# **Attachment A**

## **Building Envelope Modification Design Report**

Henning Larsen Architects have prepared a detailed building design for the Cockle Bay Park development as part of the application.

# Pymont Bridge connection

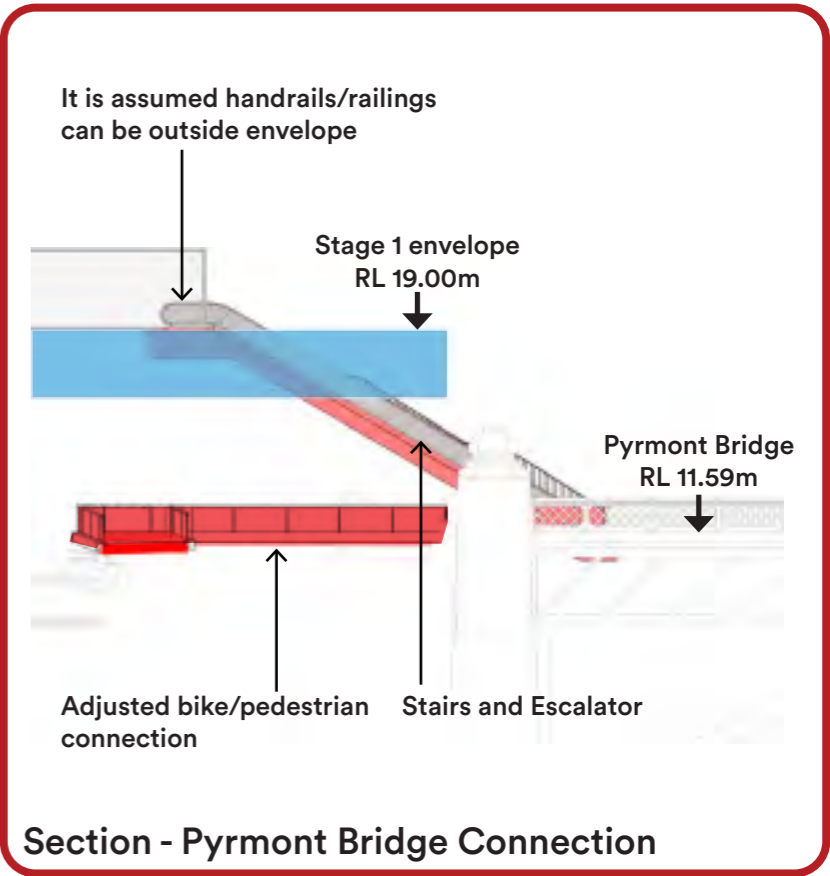
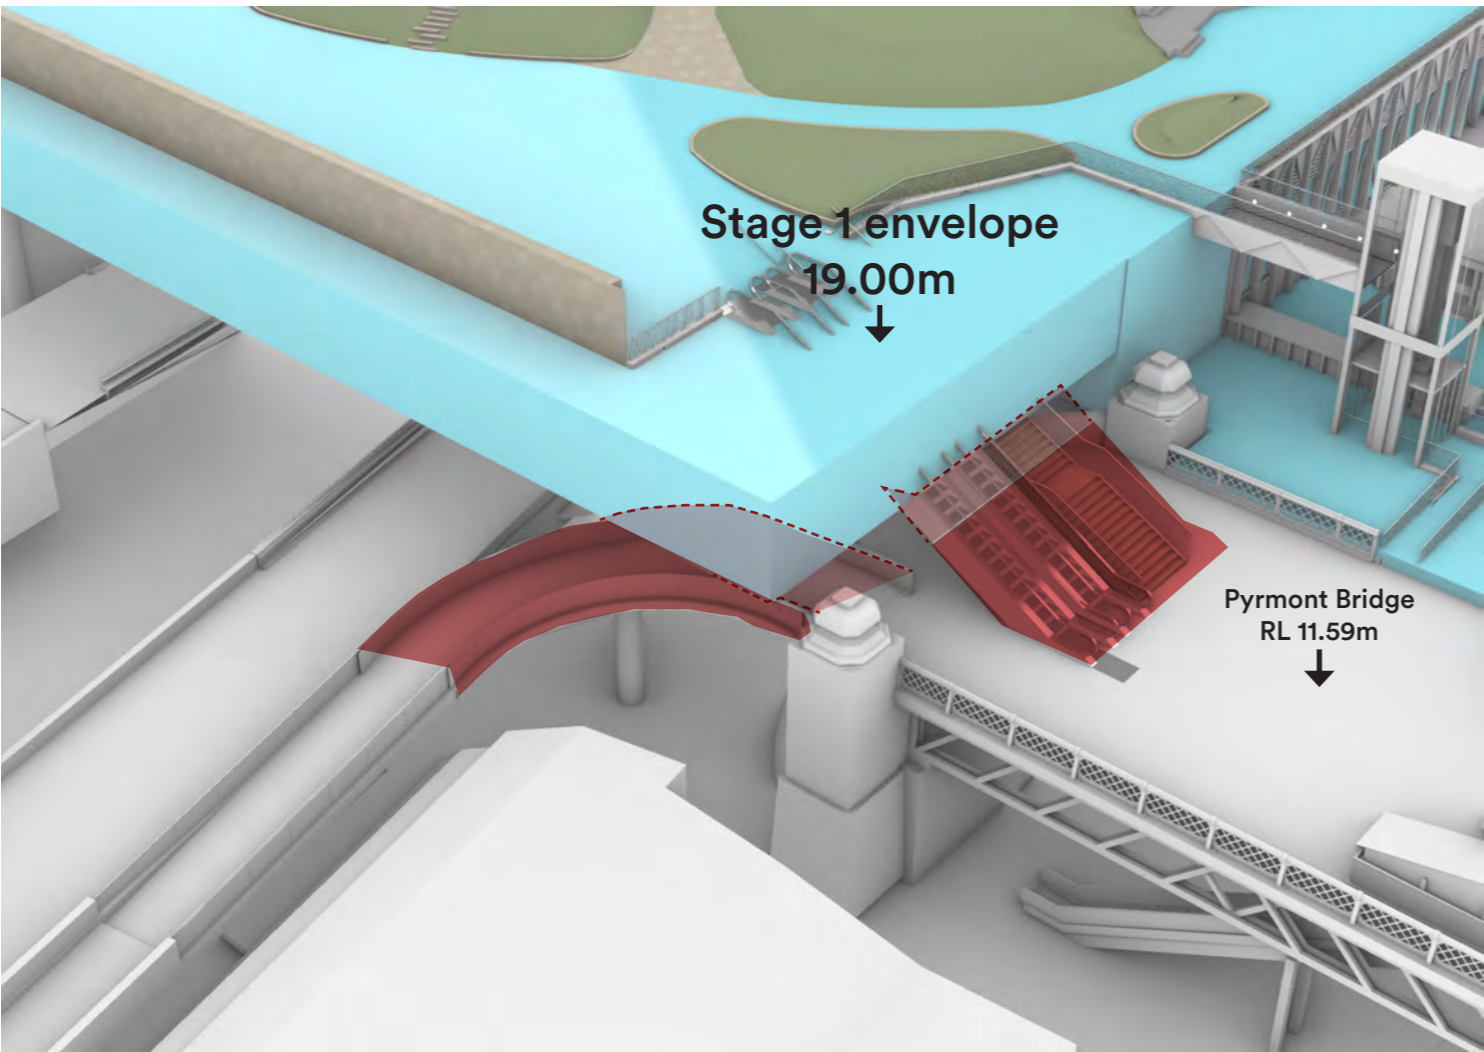
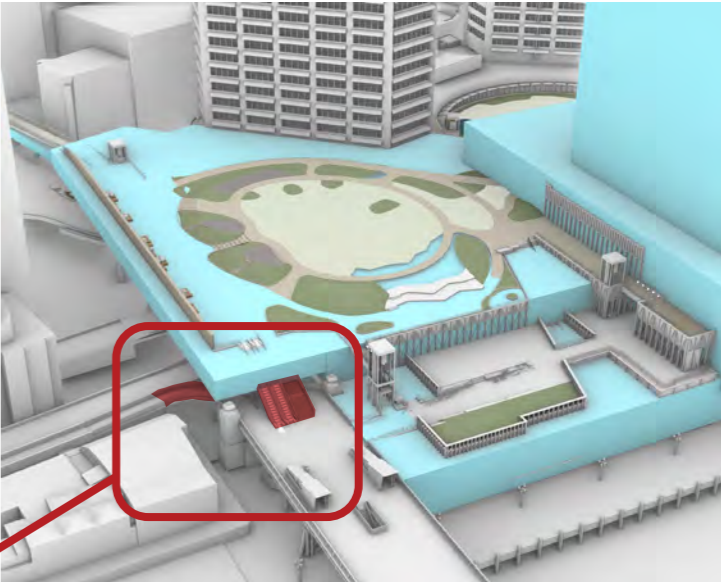
The Stage 1 DA approved envelope did not accommodate the pedestrian connection from the landbridge onto Pymont Bridge. Here, the addition of stairs and escalators, plus a realignment of the Harbour Street bicycle ramp connection, improves accessibility for pedestrians and cyclists in this area. These changes would be a positive impact on the overall project by enabling seamless pedestrian and cycle movements between Darling Harbour and the CBD through the site, connecting prominent, existing links to the new landbridge.

# Market Street Bridge connection

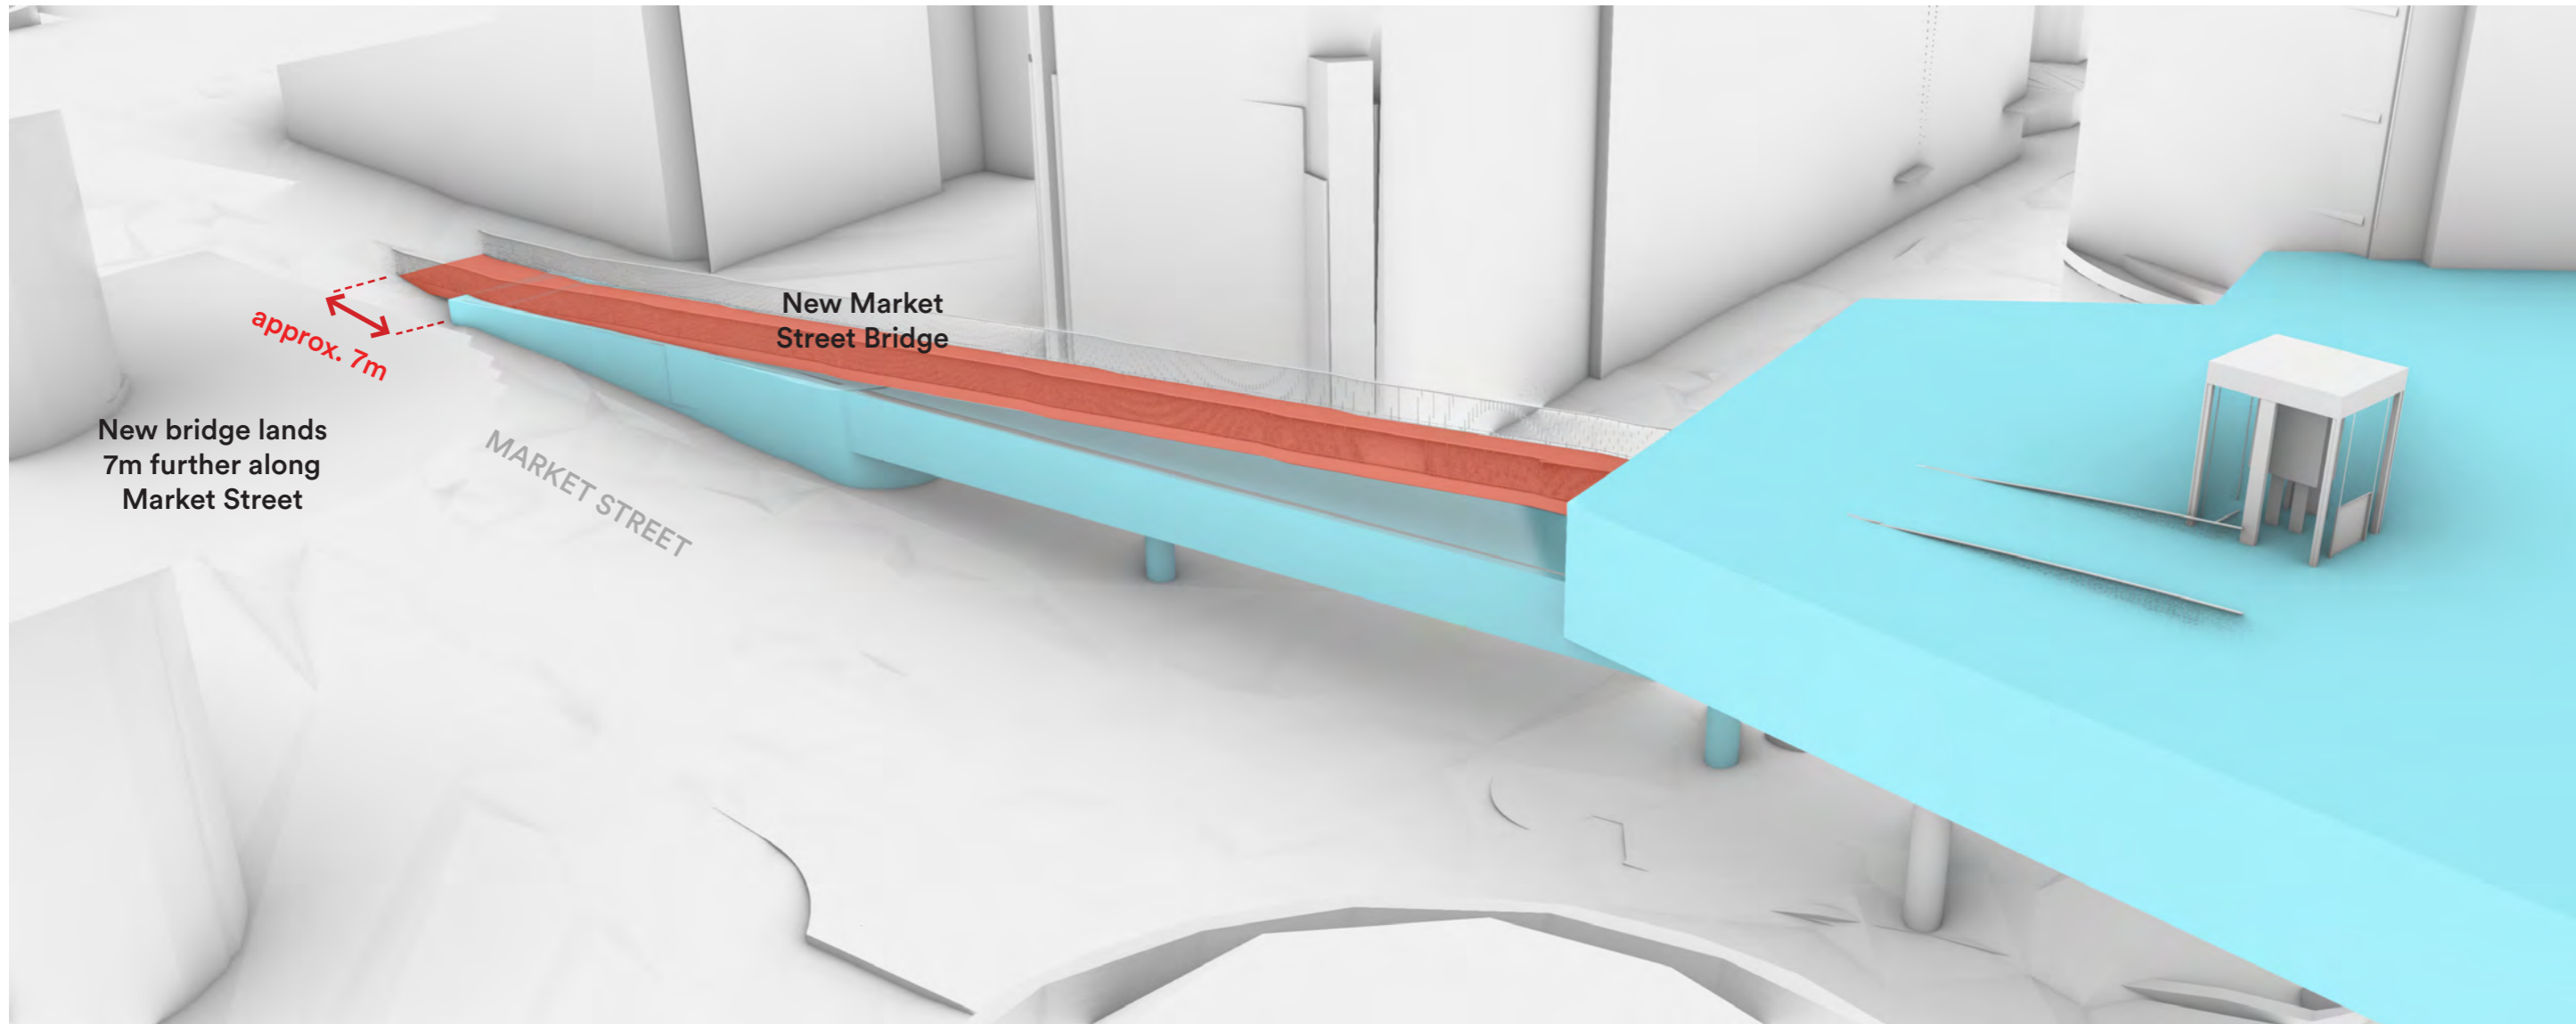
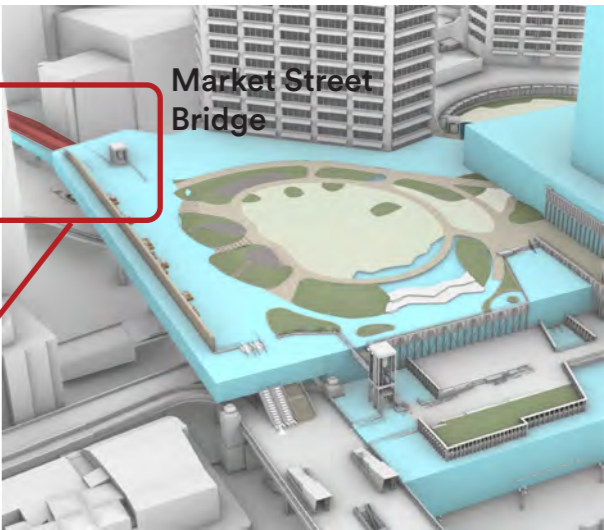
In order to provide equitable access from Market Street to landbridge level and ensure clearance requirement above the Western distributor, the design of Market Street Bridge has been refined and updated. The bridge extends further along Market Street and slopes up to a higher level to connect to the landbridge and allow passage for vehicles below. The new bridge will be DDA compliant.

## Sussex Plaza connection

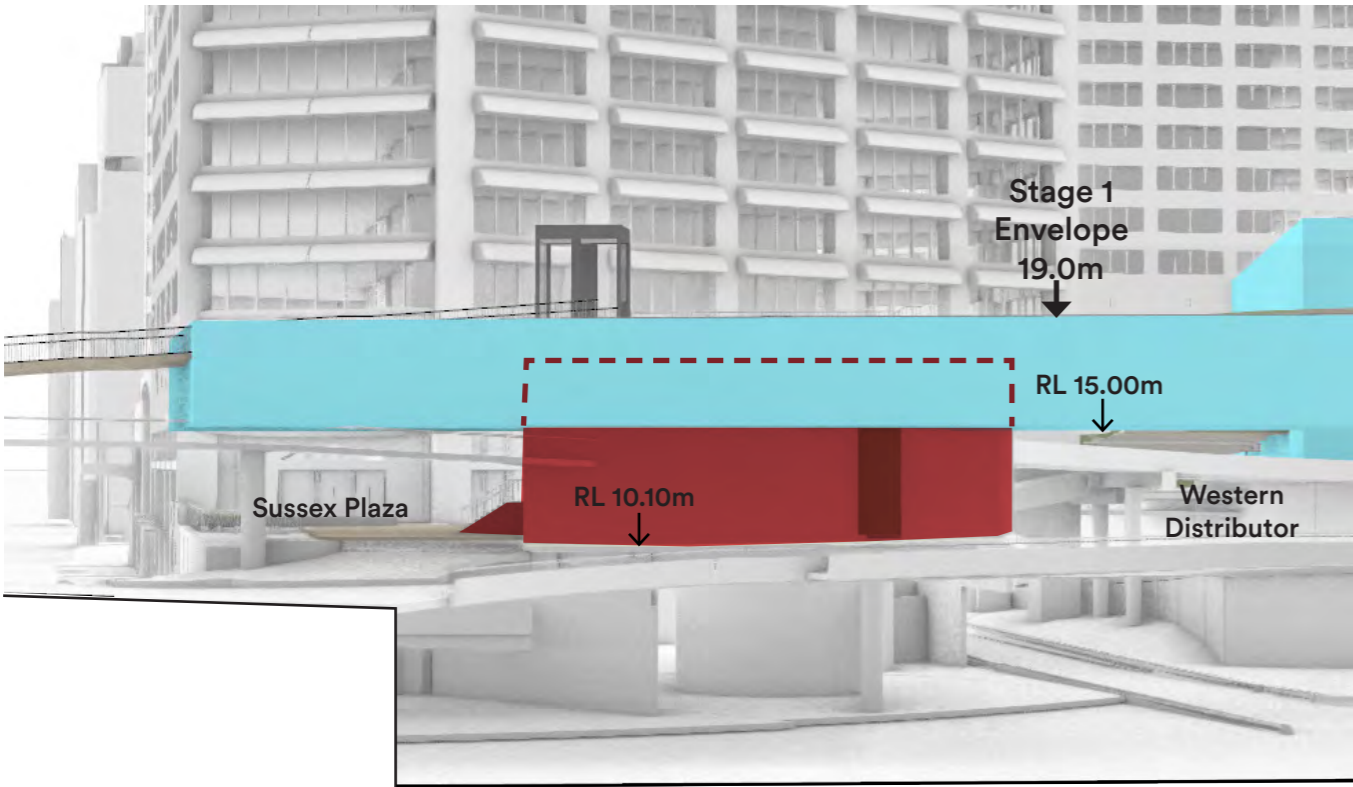
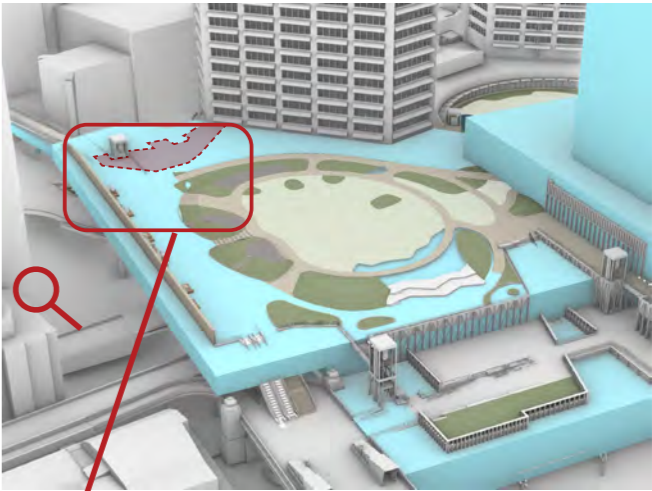
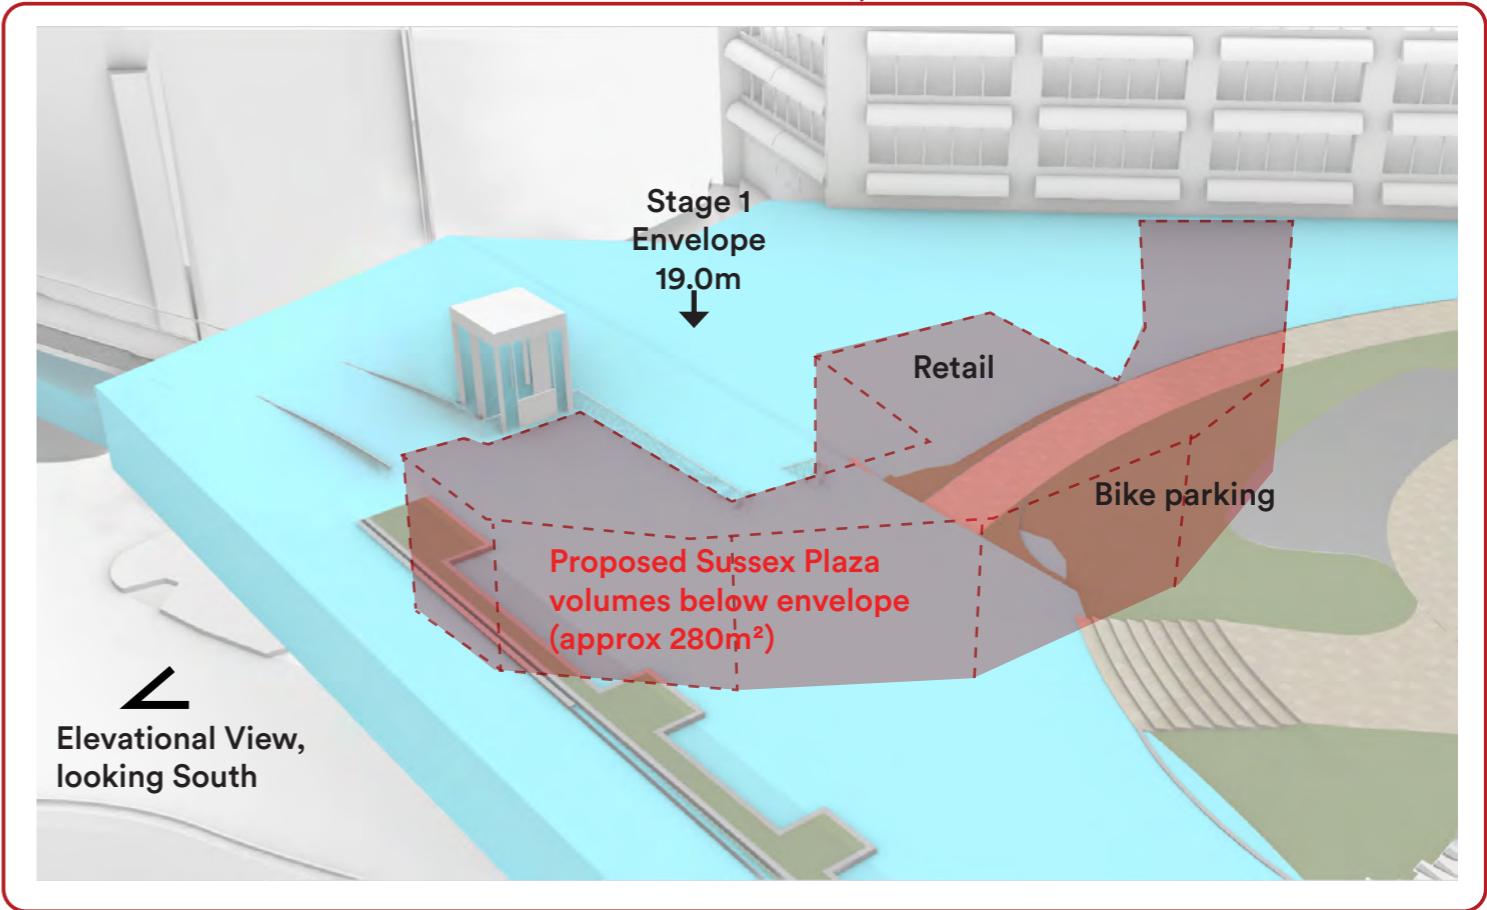
The updated scheme is proposed to include the existing retail asset within the plaza at the corner of Market Street and Sussex Street, which forms part of the site but was not previously included within the proposed development. Volumes extend below the landbridge of the Stage 1 envelope, connecting to Sussex Plaza below. Stairs, escalators and a lift provide equitable access to the landbridge from Sussex Plaza. The proposal seeks to utilise and refine an existing retail space to continue to activate the Sussex Street frontage of the site, as a gateway to the precinct.
